IREDELL COUNTY HEALTH DEPARTMENT

IMPROVEMENT PERMIT / AUTHORIZATION TO CONSTRUCT / OPERATION PERMIT / EXISTING SYSTEM INSPECTION

PERMIT# 110098 PIN# 4775-04-8444 DATE 02-07-03

SUBDIVISION SPRING FOREST BLOCK / SECTION ____ LOT 32 LOT AREA .8467 SITE CLASS PS DESIGN FLOW 360 L.T.A.R. .35

INITIAL SITE SKETCH

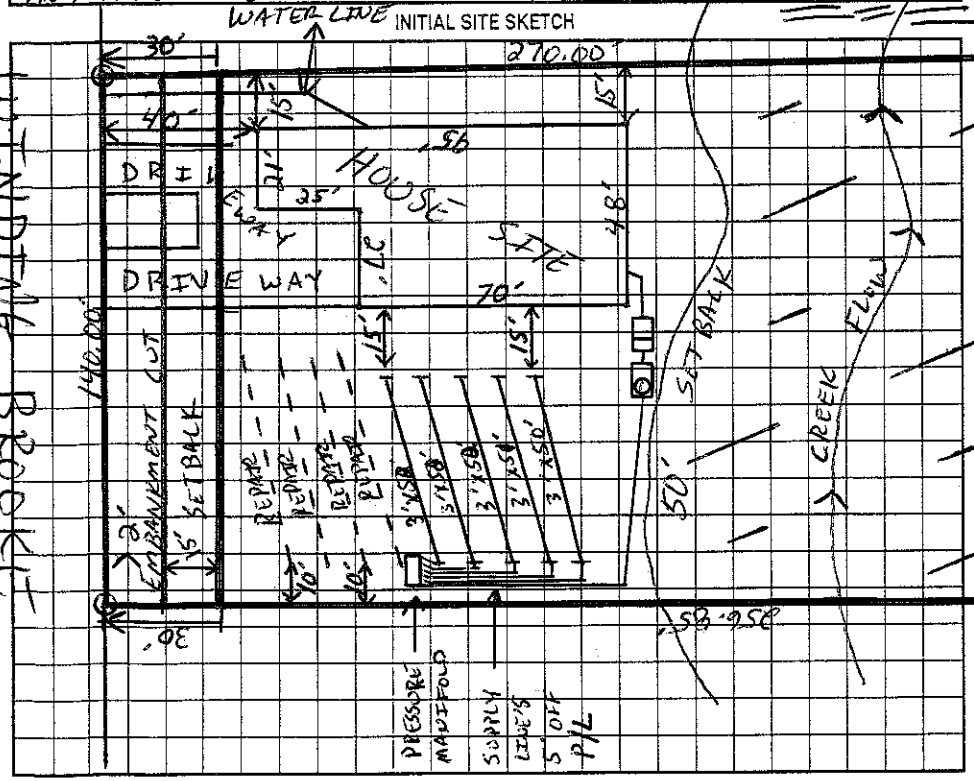
Comments/Conditions: (1) NOTE THE MAXIMUM TRENCH BOTTOM DEPTH (2) MAINTAIN SETBACKS (3) INSTALL LINES ON CONTOURS AS FLAGGED. (4) LOT IS EXTREMELY TIGHT WITH THE SETBACKS, IF ANY UNAUTHORIZED CHANGES OCCUR THIS PERMIT WILL BE VOID!

Comments/Conditions: (5) DUE TO SOIL WETNESS AT THE TANK AREA, THE TANKS WILL HAVE TO BE TESTED FOR LEAKS B4 OP IS SIGNED OFF ON. (6) CALL PRIOR TO INSTALLATION FOR PUMP SIZING INFO. (7) DO NOT CUT SOILS IN REPAIR AREA, ONLY HAVE ENOUGH SOIL DEPTH FOR A 6" CAP FOR REPAIR.

AS BUILT SKETCH NOW FOR A 6" CAP FOR REPAIR

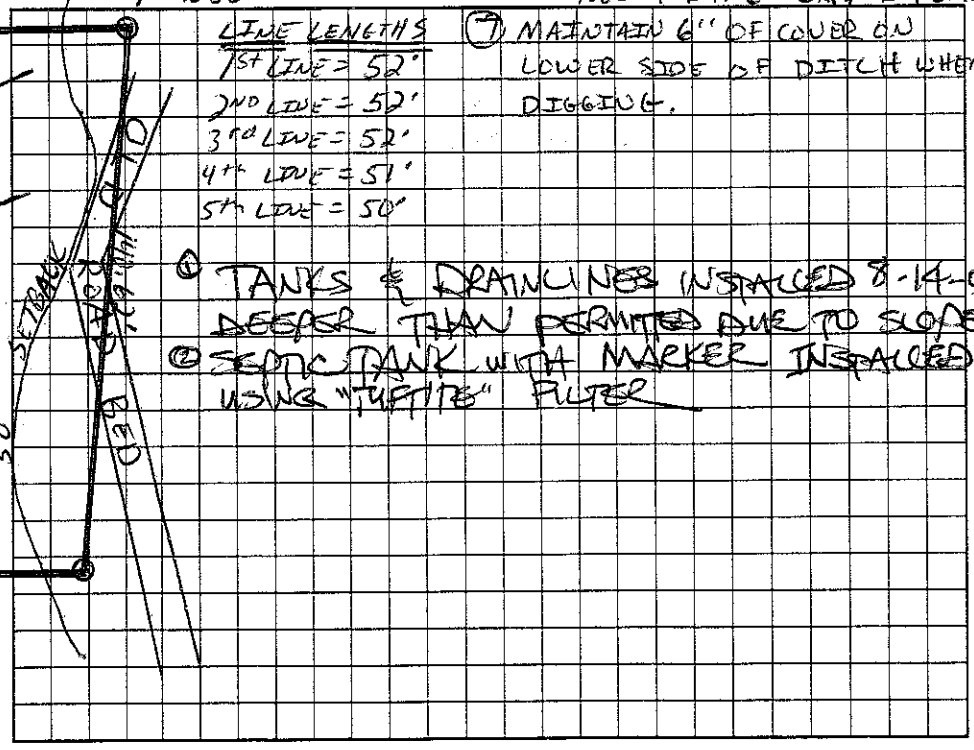
(7) MAINTAIN 6" OF COVER ON LOWER SIDE OF DITCH WHEN DIGGING.

(1) TANKS & DRAINLINES INSTALLED 8-14-03 DEEPER THAN PERMITTED DUE TO SLOPE (2) SEPTIC TANK WITH MARKER INSTALLED USING "TUFTITE" FILTER
